SINGAPOREAN NOTICES TO MARINERS

I
AFFECTED CHARTS AND PUBLICATIONS

6. Page 58
Replace Chartlet on page 58 with the Chartlet 1 attached.

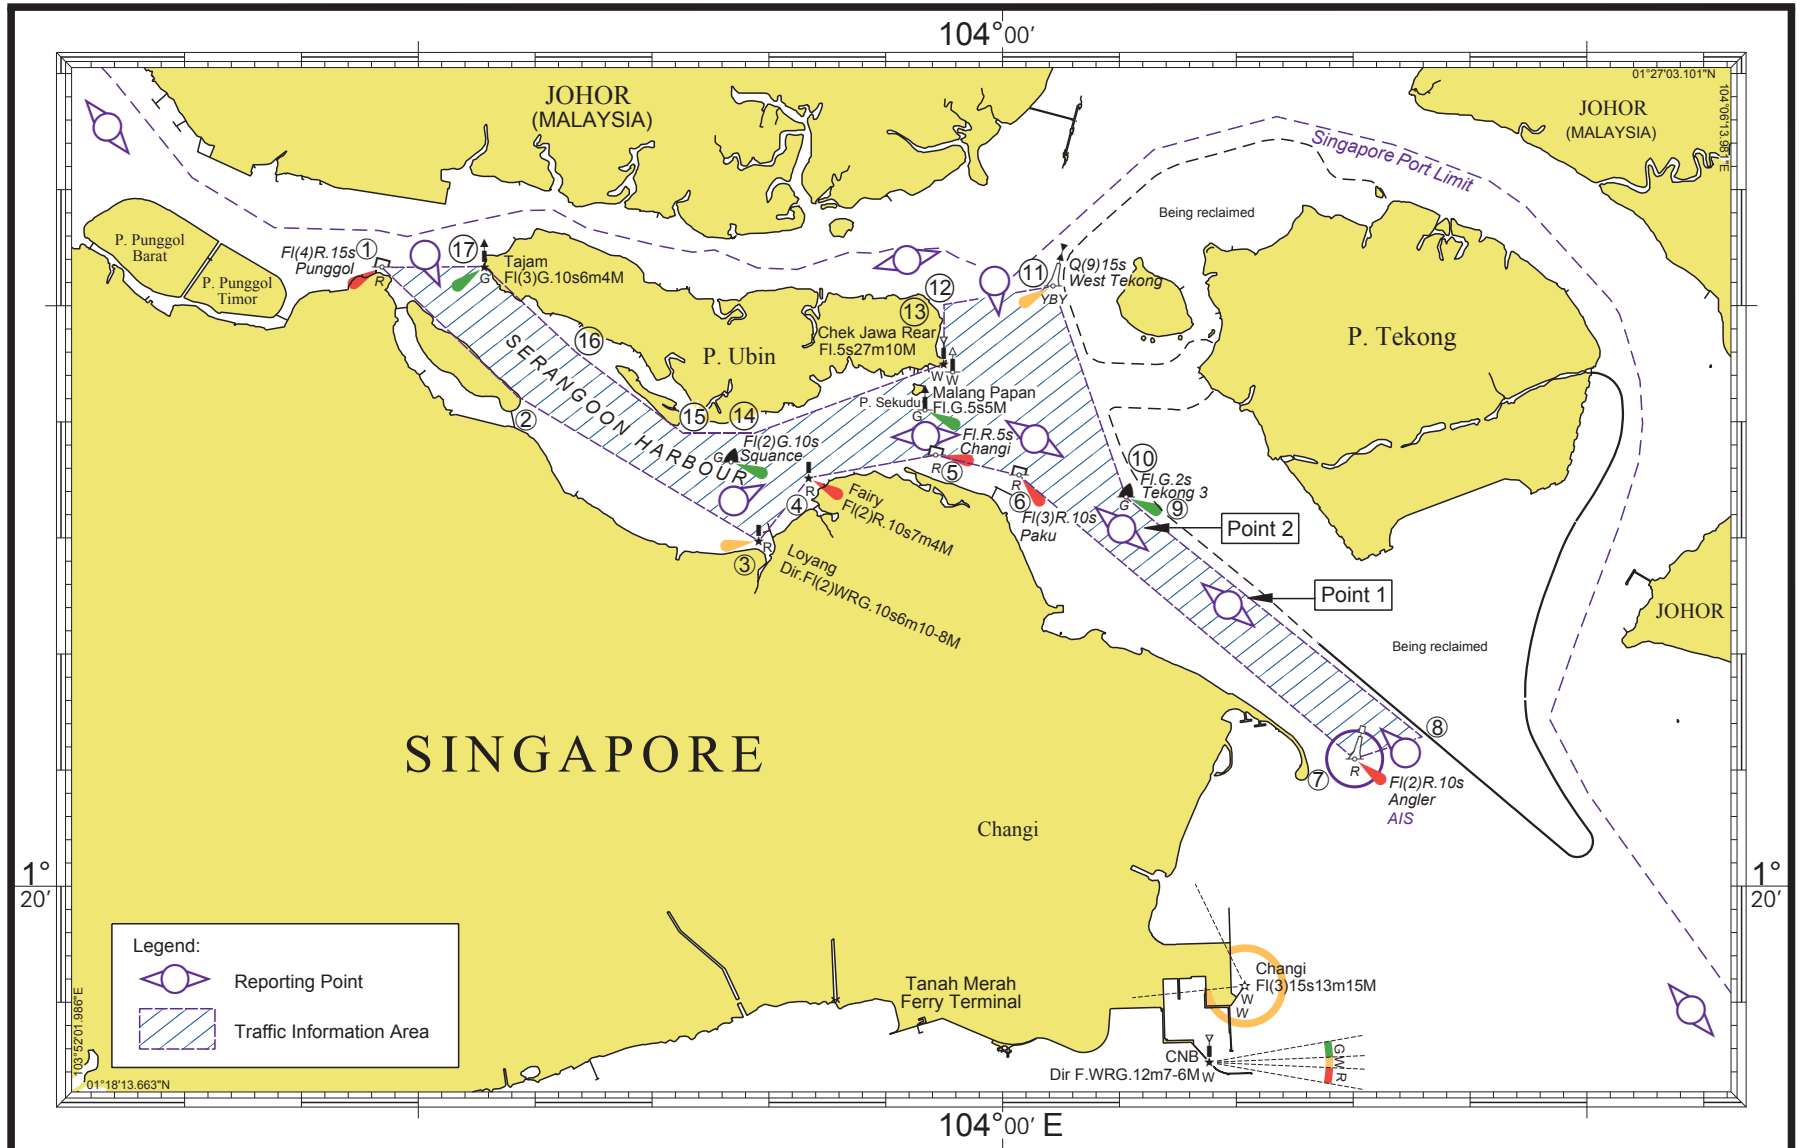
7. Page 59
Replace Chartlet on page 59 with the Chartlet 2 attached.

| CORRECTION NO. | SNM EDN NO. | LAST CORR N NO. | CHART NO. | Location on Chart | | |
|----------------|-------------|-----------------|-----------|-------------------|---|--|
| 72 | 11/2020 | 65/2020 | GSP1/SP1 | | | |

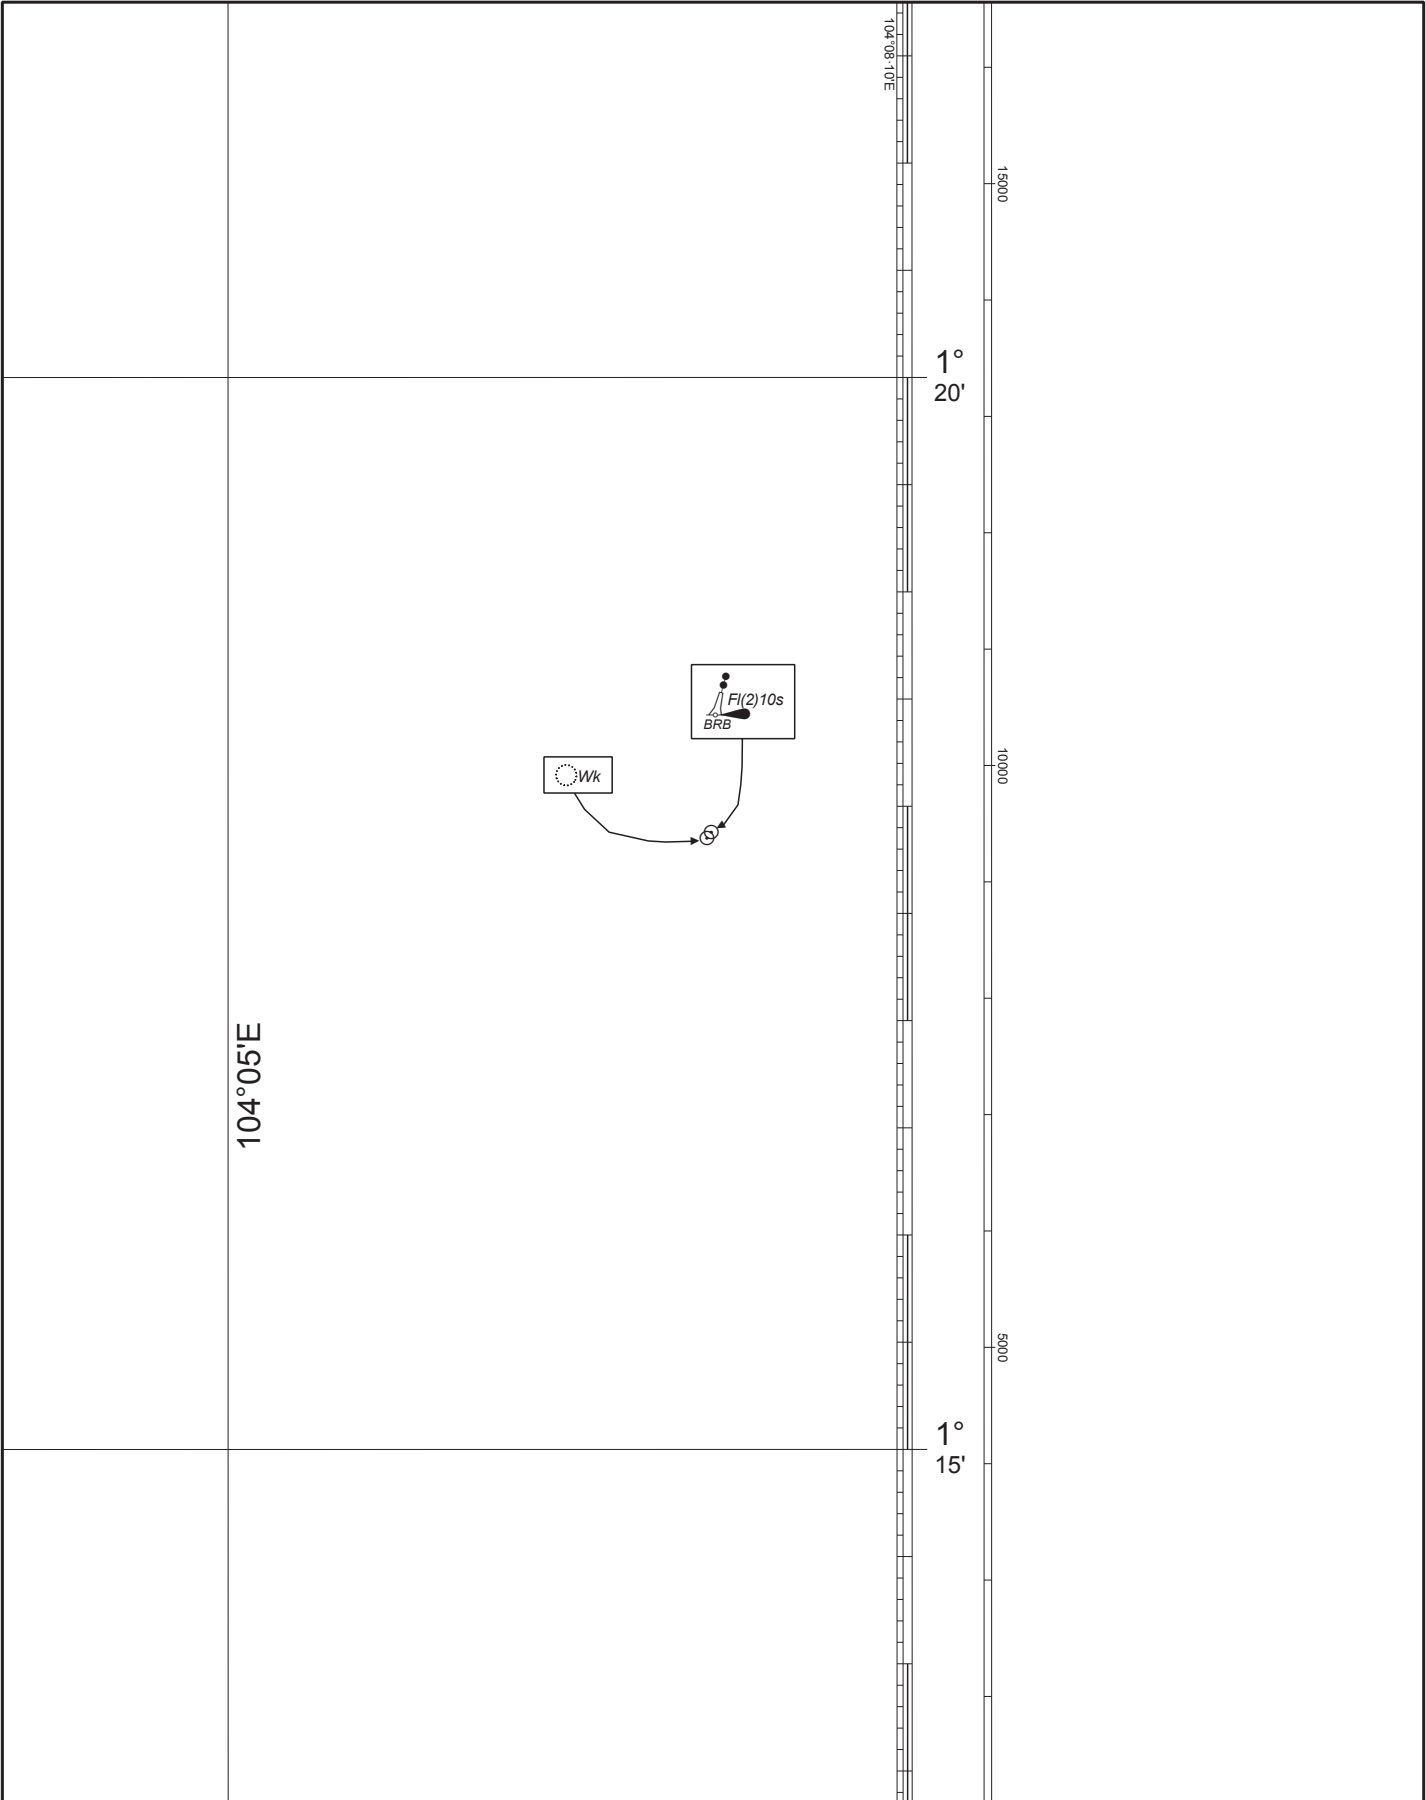
| GSP1/SP1 | 4 Ed 15/02/20 Last NM 65/2020 | (Maritime and Port Authority of Singapore) | NM 72/2020 |
| Insert |  Q(6)+LFl.15s South Ubin | 1°24·04' N | 103°58·22' E |

| CORRECTION NO. | SNM EDN NO. | LAST CORR N NO. | CHART NO. | Location on Chart | | |
|----------------|-------------|-----------------|-----------|-------------------|--|---|
| 73, 74 | 11/2020 | 72/2020 | GSP1/SP1 | | | X |

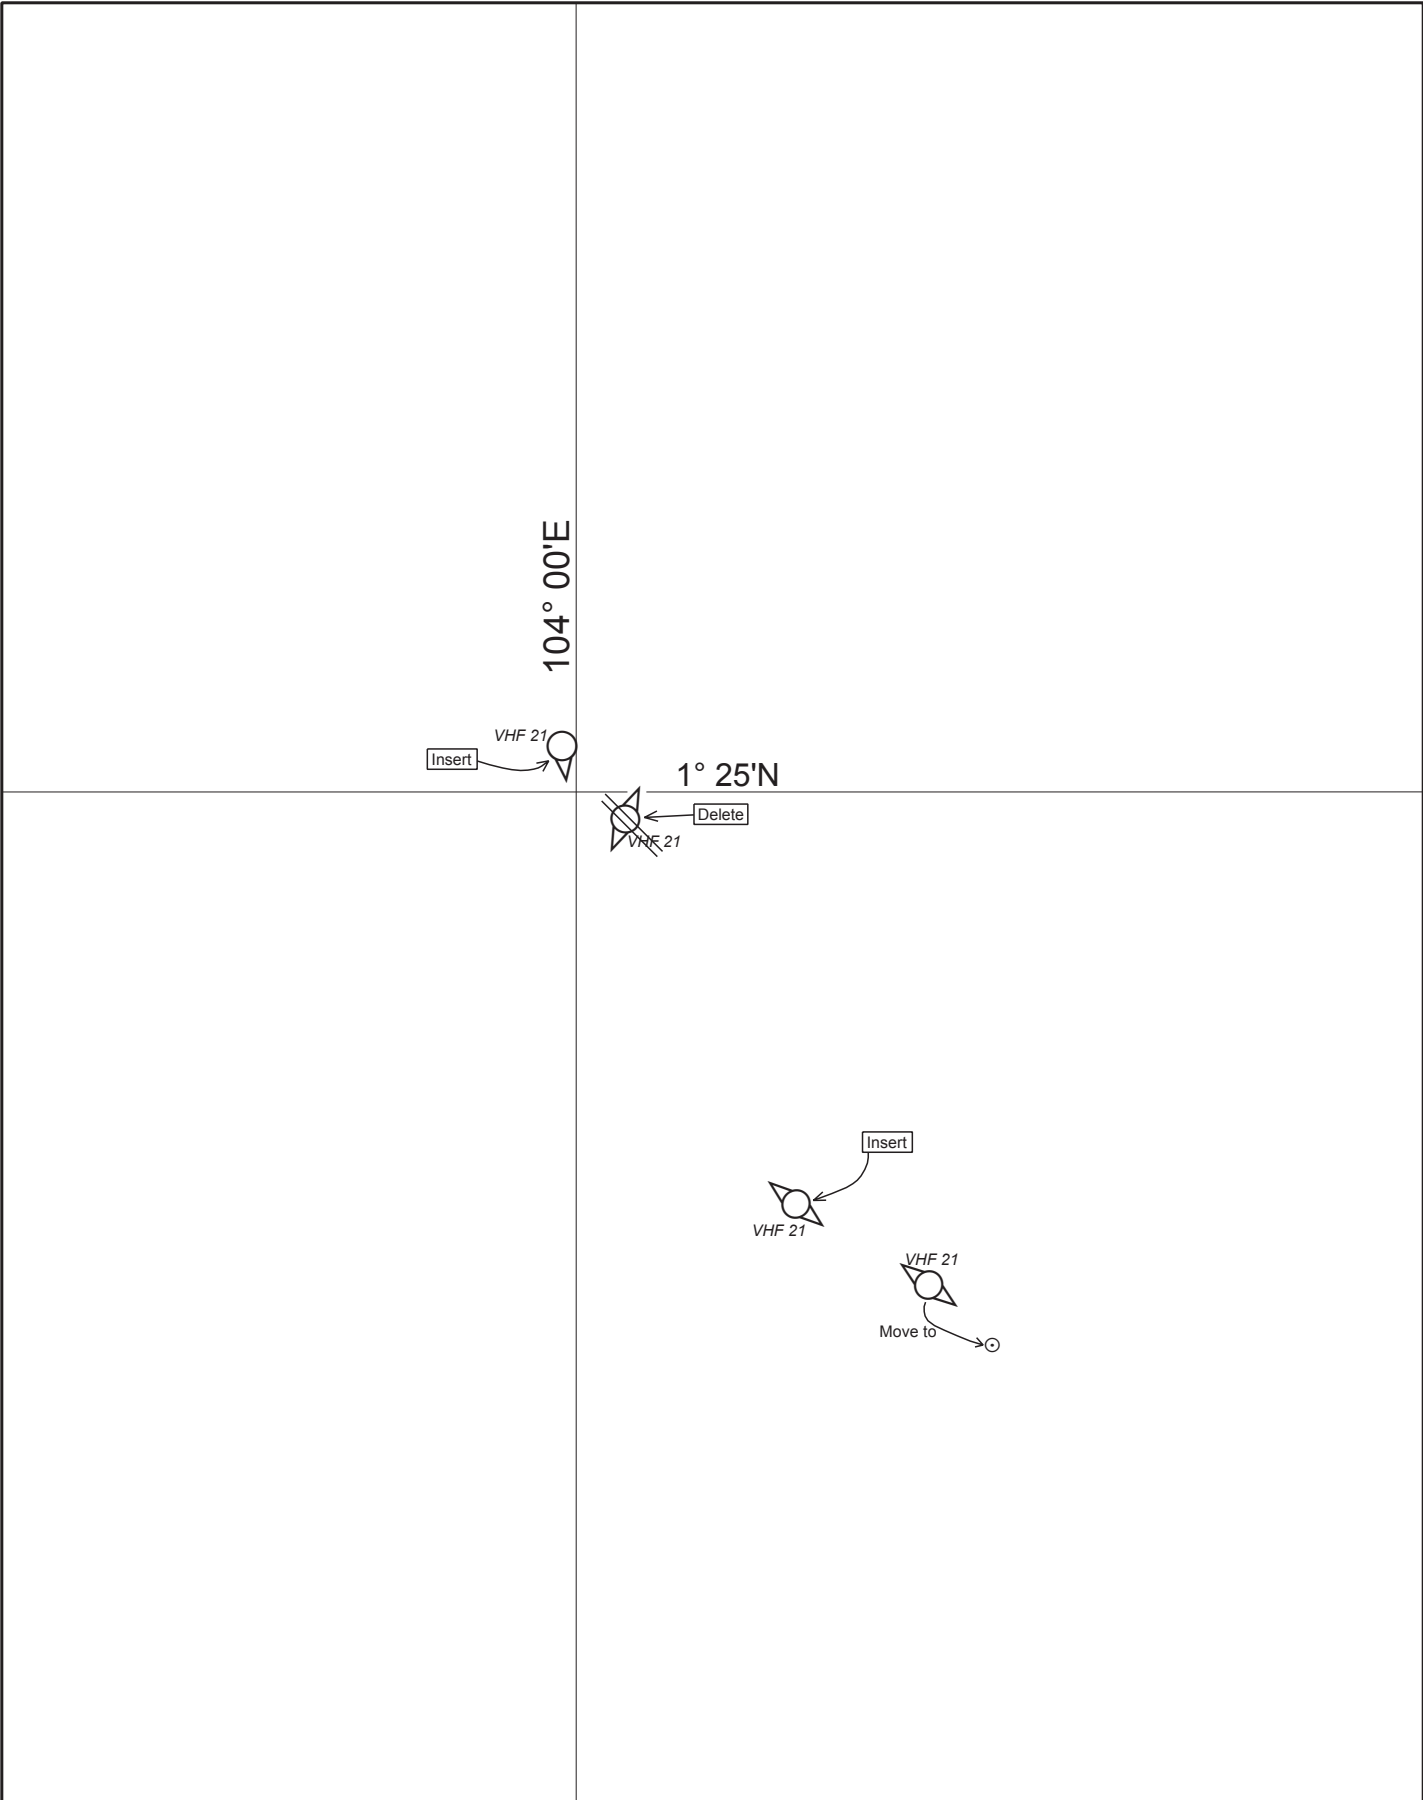
| | | (Royal Malaysian Navy Notice no. 7/137T/2017) | NM 73/2020 |
| Insert |  Wk | 1°17·85' N | 104°07·22' E |
| | | (Royal Malaysian Navy Notice no. 11/262/2018) | NM 74/2020 |
| | | <i>Note:</i> Former notice 74T/2017 is cancelled | |
| Insert |  Fl(2)10s | 1°17·88' N | 104°07·24' E |

| CORRECTION NO. | SNM EDN NO. | LAST CORR N NO. | CHART NO. | Location on Chart | | |
|----------------|-------------|-----------------|-----------|-------------------|--|---|
| 75 | 11/2020 | 74/2020 | GSP1/SP1 | | | |

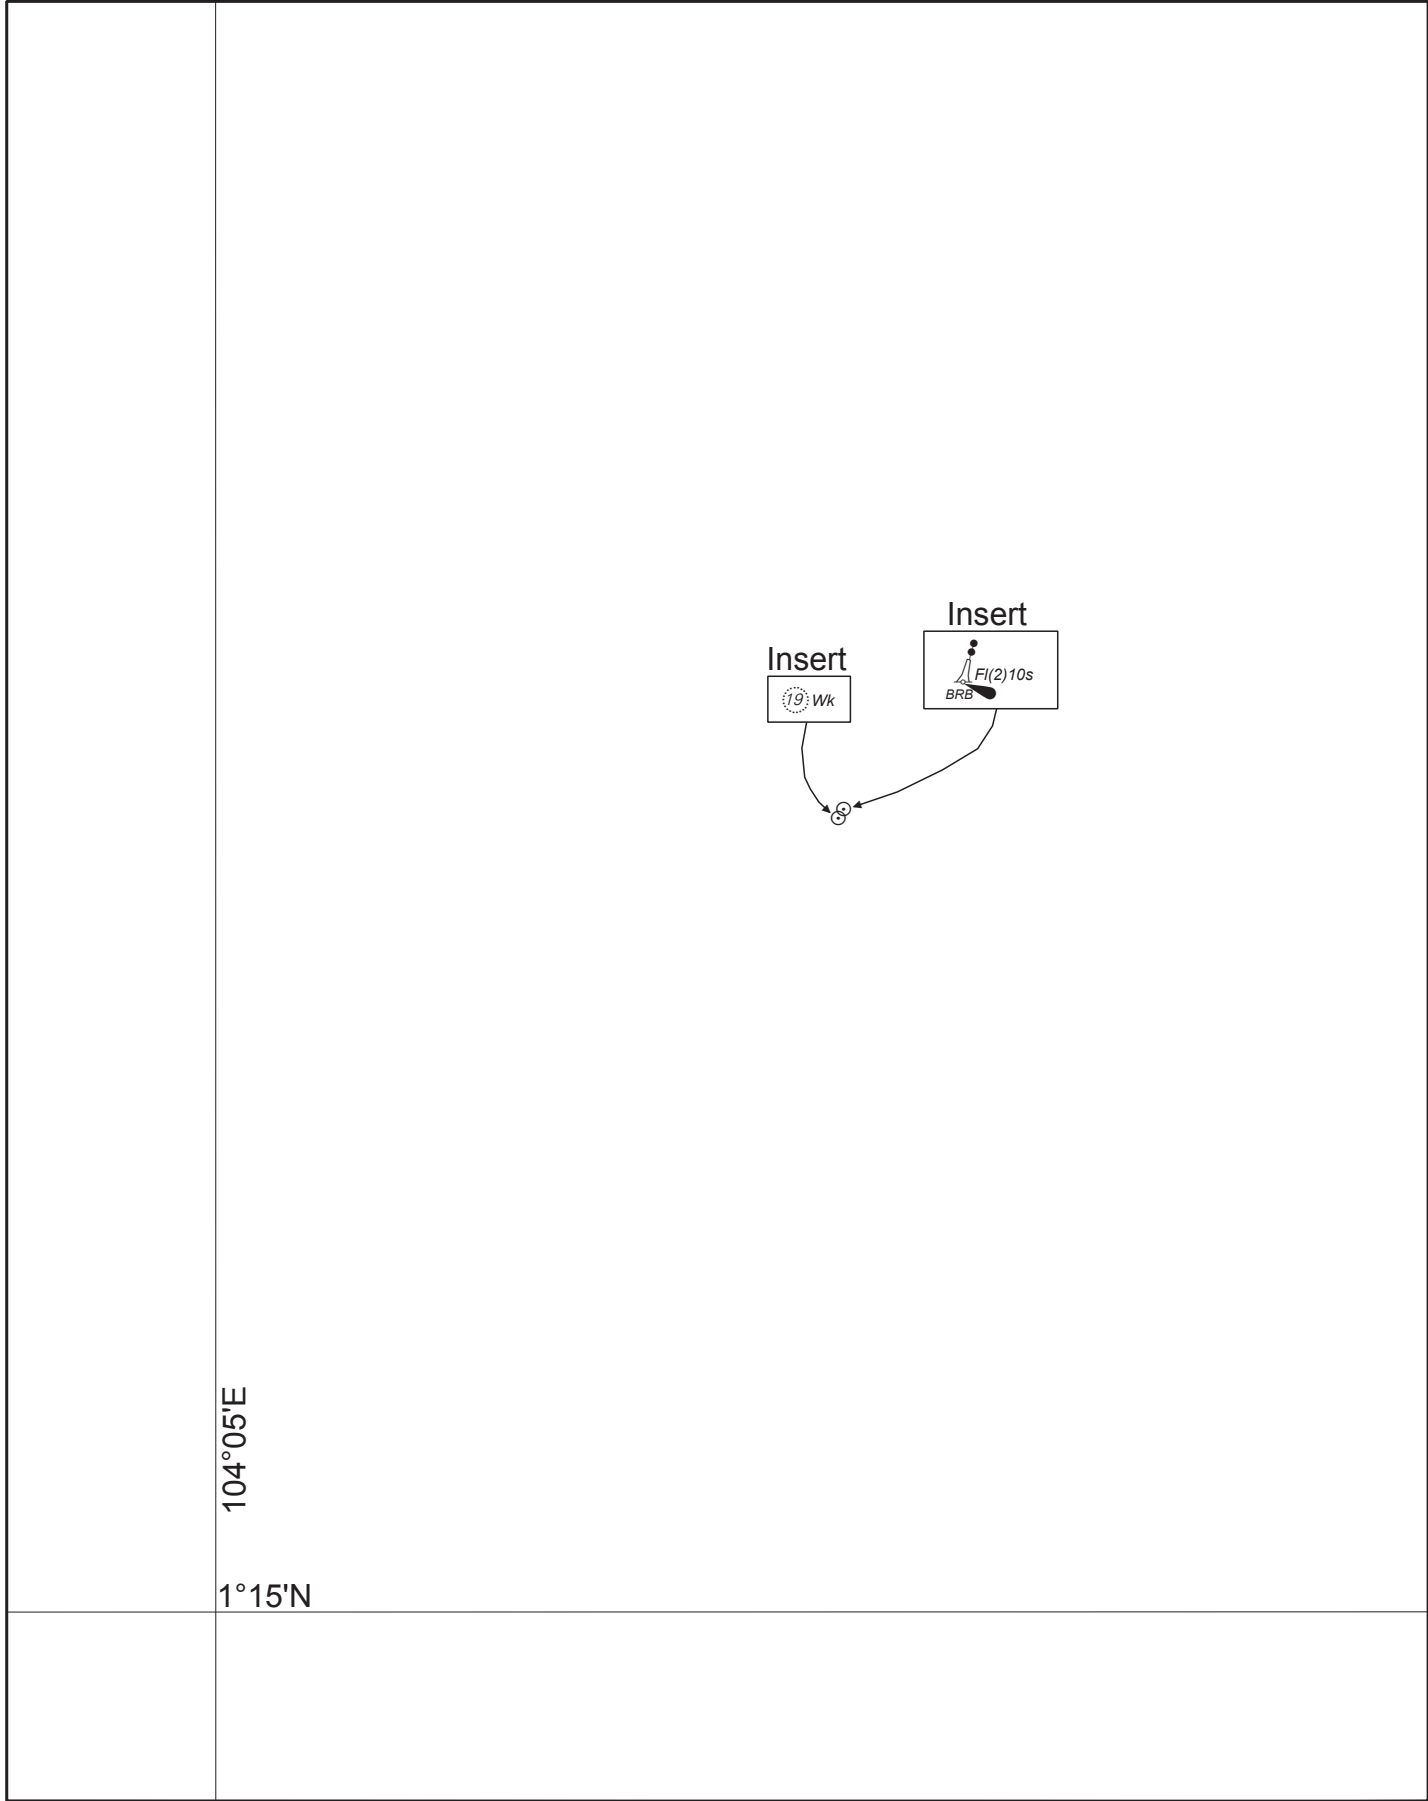
| | | (Maritime and Port Authority of Singapore) | NM 75/2020 |
| | | <i>Note:</i> These changes will come into operation on 27 November 2020 | |
| Delete |  VHF 21 | 1°24·87' N | 104°00·23' E |
| Move |  VHF 21 | from: 1°22·70' N to: 1°22·42' N | 104°01·64' E 104°01·93' E |
| Insert |  VHF 21, direction of vessel movement 129°/309° | 1°23·08' N | 104°01·02' E |
| |  VHF 21, direction of vessel movement 173° | 1°25·21' N | 103°59·93' E |
